CITY OF ALBUQUERQUE

**Re: Picasso RV - 7800 Jacs Ln. NE
Grading & Drainage Plan Engineer's Stamp Dated 11/21/2017
(D16D002A6)**

**RE: Picasso RV- 7800 Jacs Lane
Drainage file E16D002A6**

**Re: Picasso RV - 7800 Jacs Ln. NE
Grading & Drainage Plan Engineer's Stamp Dated 10/31/2017
(D16D002A6)**

SECTION C-C
NTS

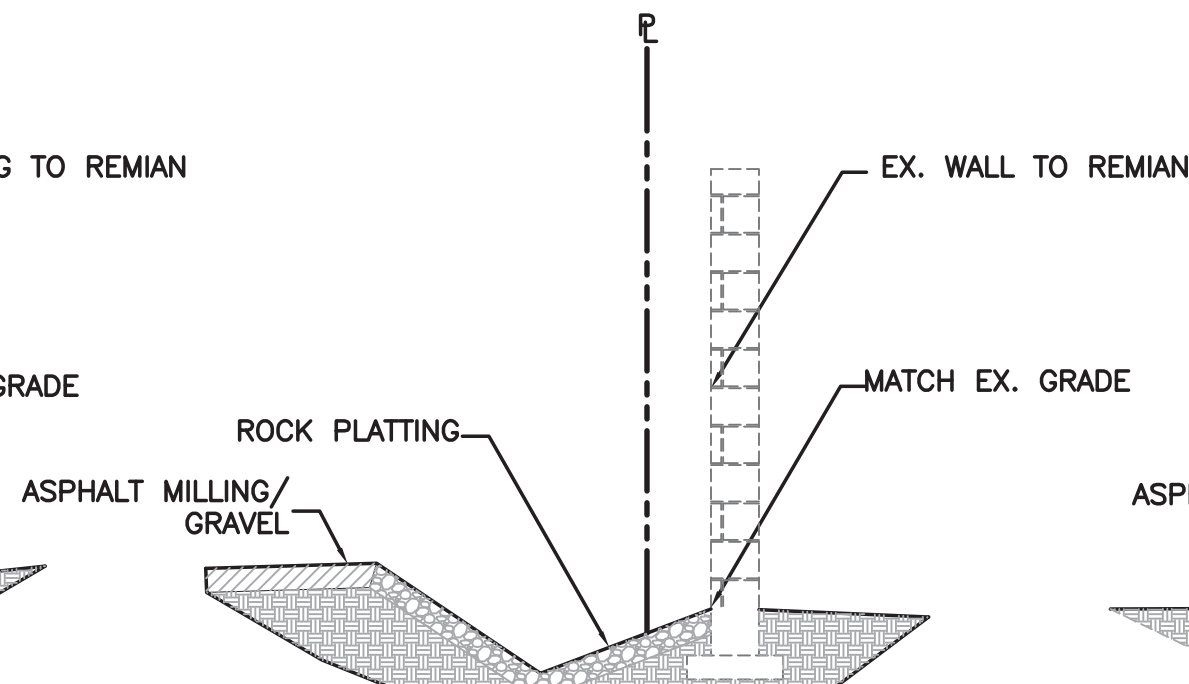
3. Similarly the hydraulic capacity calculations of the swale in section C-C should either be revised in the report to match the geometry of the section on the G&D Plan or the revised calculations can be shown on the G&D Plan next to the section. The detail and the calculations should agree.

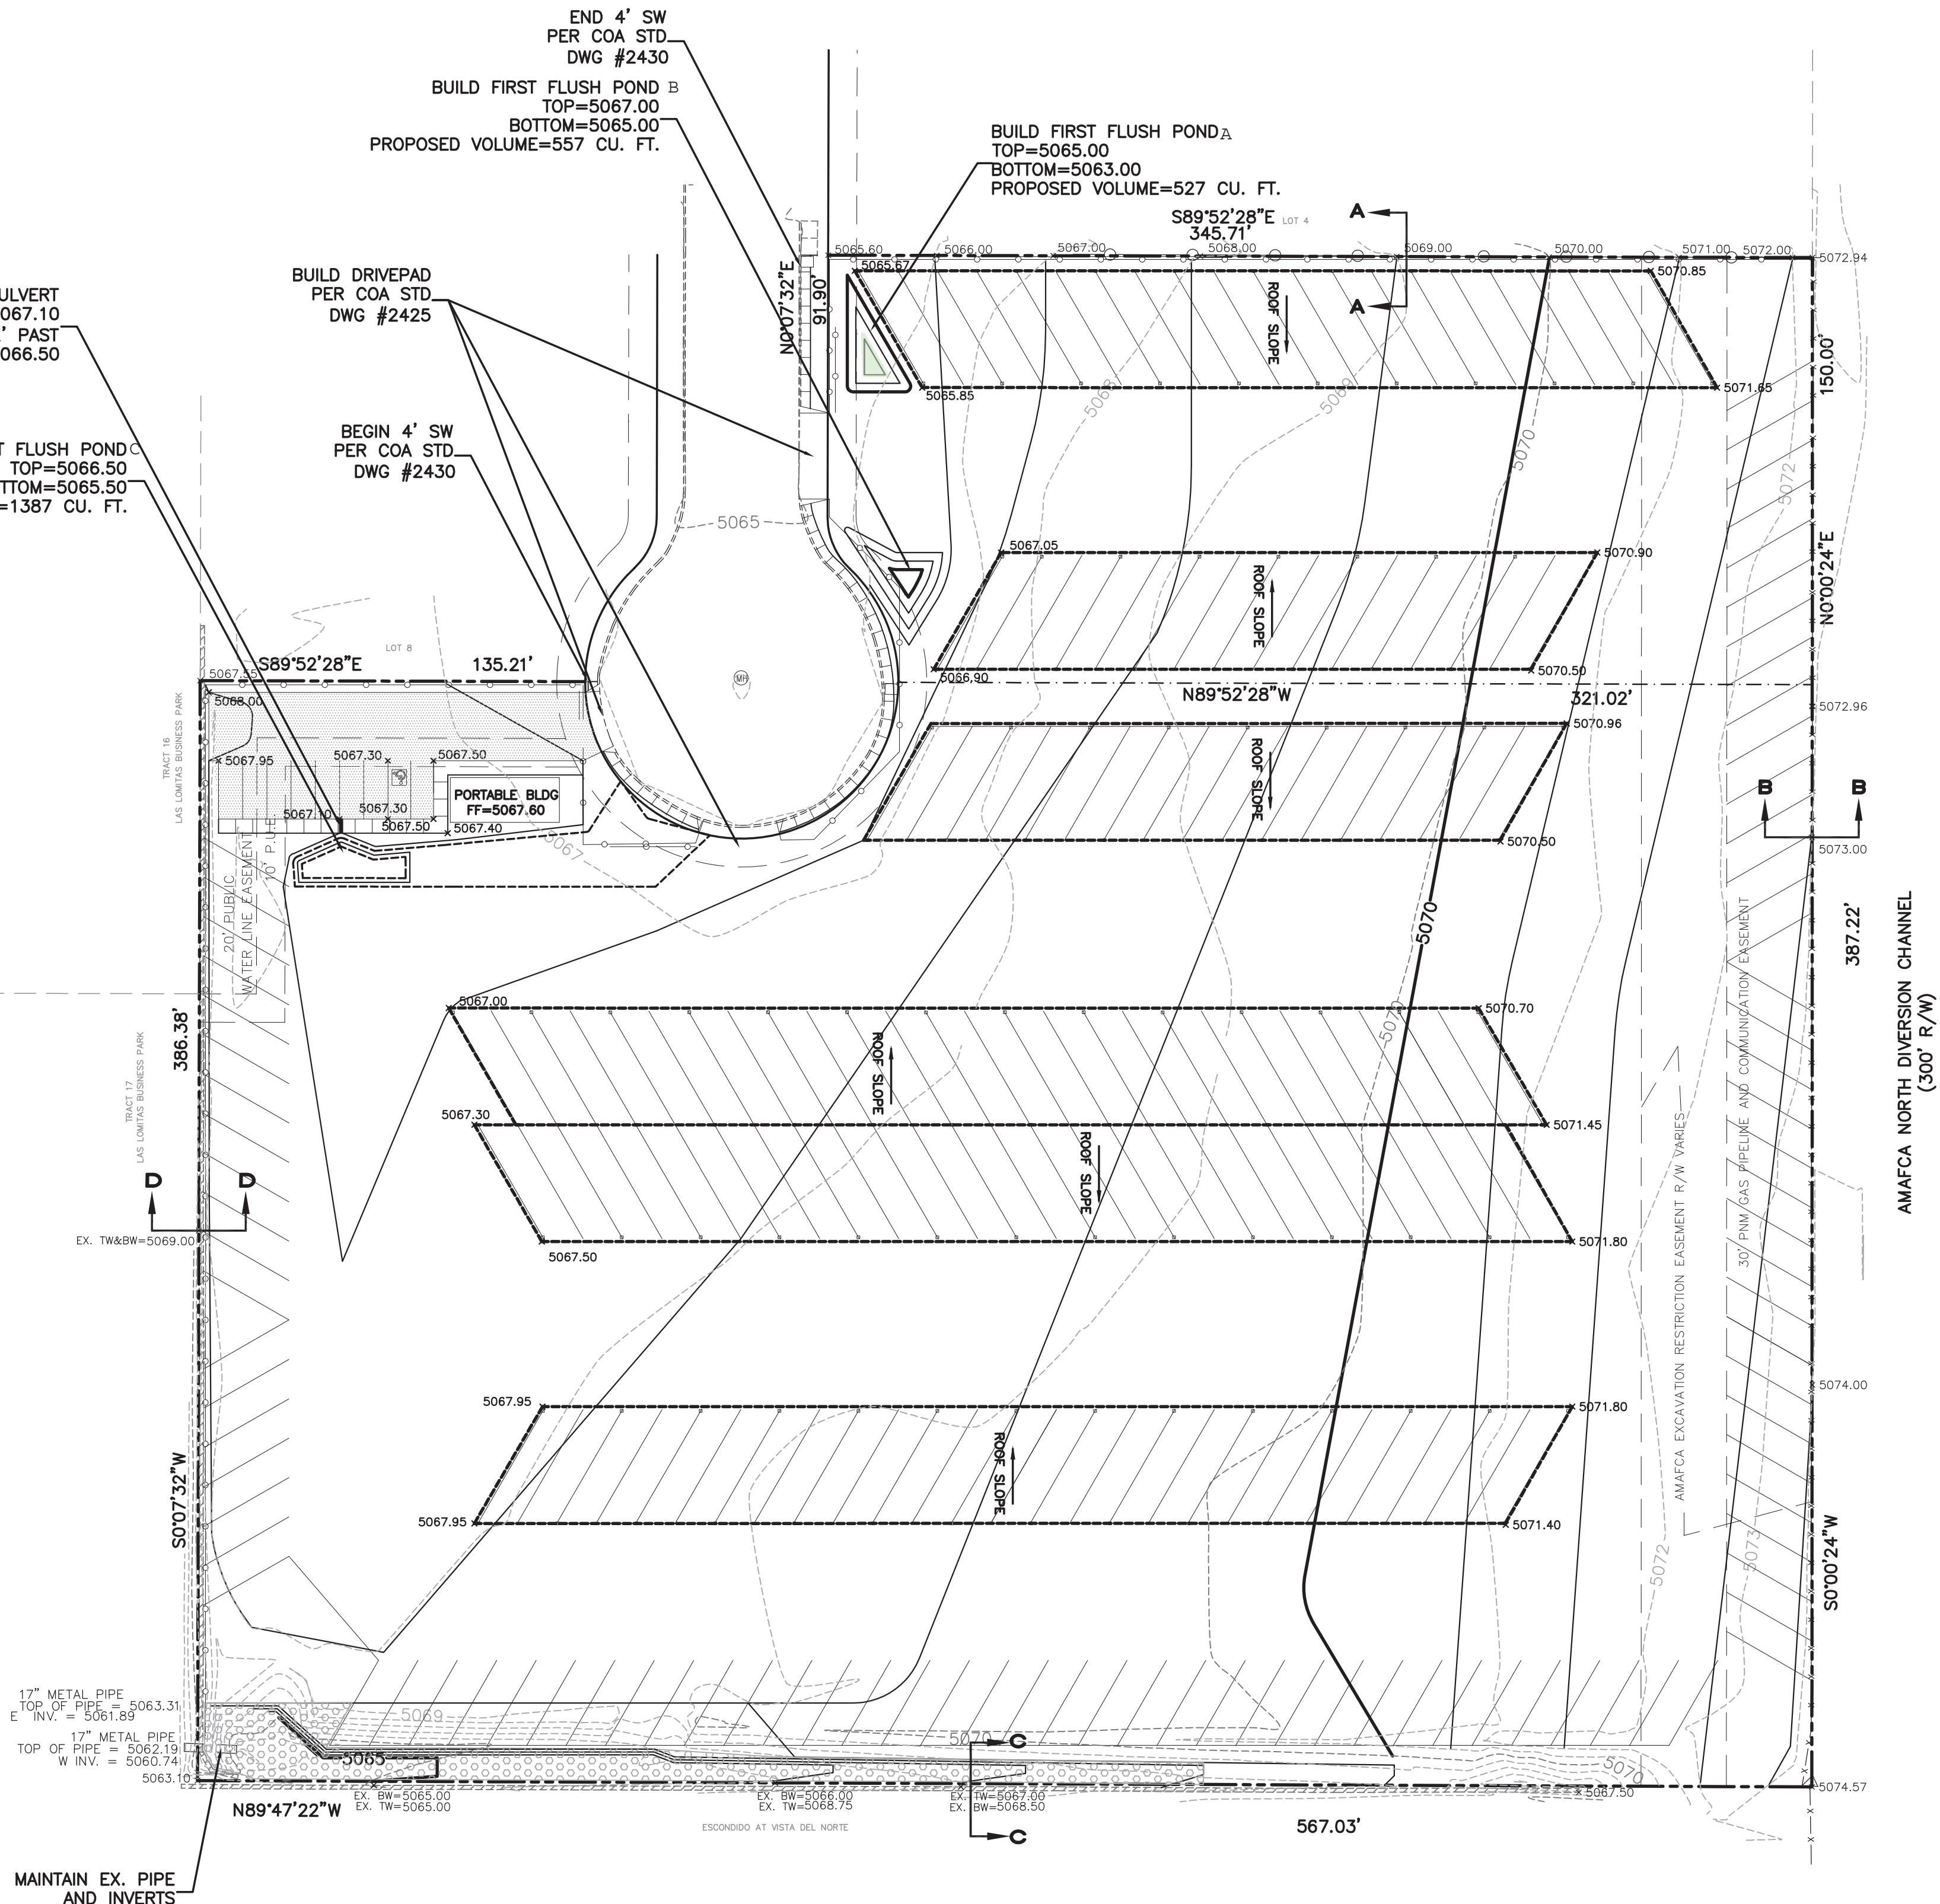
1. Flow arrows and spot elevations should be added showing the onsite swale next to Jacs Ln. that will divert onsite drainage into the ponds before it enters the public right of way.

2. A typical section showing the horizontal and vertical dimensions from the right of way line of Jacs Ln. to the curb and gutter, sidewalk, and onsite drainage swale should be shown on the G&D Plan. Hydraulic capacity calculations should be shown next to the section of the onsite swale.

4. Please add a big caution note in the vicinity of the existing 30' PNM Gas Pipeline and Communication easement on the east side of this property.
5. Written approval of this plan is required from PNM.
